Description of document: General Services Administration (GSA) Infrastructure

Assessment for the Weaver Building (the HUD

STRUCTURAL ASSESSMENT REPORT

Robert C. Weaver Garage Feasibility Study Final Report Submission

Photo Seal-5: Concrete screen wall at Southeast Wing

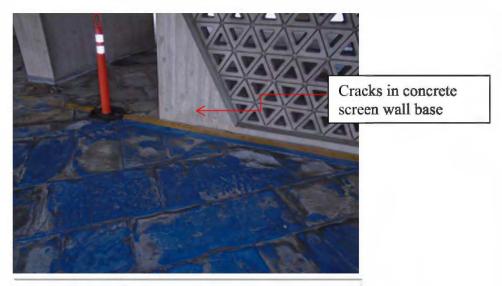
Based on the findings from the water tests and destructive testing, the portion of the Southeast Wing without any waterproofing is extremely vulnerable to water intrusion and further damage to the concrete structure below. The leaks have greatly impacted the on-going fitness center operation below, which include a myriad of high-tech gym equipment directly below locations of leaks. In addition, the concrete screen walls on the Southeast Wing were found to be a source of leaks in to the building. Cracks in the screen wall provide a direct pathway below the paving system and ultimately into the building. We suggest the pavers at this section be removed, the structural concrete deck be repaired, and a hot-applied rubberized asphalt waterproofing membrane with protection and drainage board be installed. Following completion of the waterproofing installation, the paving system can be restored.

to terminate the waterproofing and provide reliable performance while avoiding the cost and potential historic impact associated with removing and rebuilding the screen walls. We recommend removing the concrete screen walls entirely and installing a sloped lightweight concrete topping slab that slopes to floor drains in the paving system.

- A. Remove existing paving system down to the structural concrete deck and install a reinforced hot-applied rubberized asphalt waterproofing system, protection board, drainage board, concrete topping slab and reinstall the existing bluestone pavers.
- B. Terminate new waterproofing on concrete base of screen wall to avoid disassembling and removing the concrete screen wall.
- C. Install three (3) plaza drains in the above area to improve drainage.
- D. Crack injection at below grade walls in Room B100.
- E. Two (2) Link Seals at storm water pipes in Room B100.
